36/3-93A 8200 Meadowbrook Lane
Rock Creek Stables

SUBJECT: Historic Area Work Permit Application

HISTORIC PRESERVATION COMMISSION STAFF REPORT

PROPOSAL: Construct shed

The Cottage (GABLE ROOF)

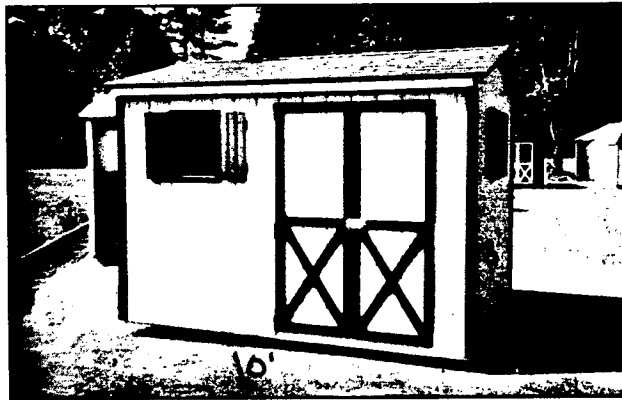
The staff recommends that the design of the shed be altered to make it more consistent with the architectural character of the barn, specifically by the addition of thin battens over the grooves in the T-111, by the use of casement or sash windows rather than jalousies, and by the removal of the shutters.
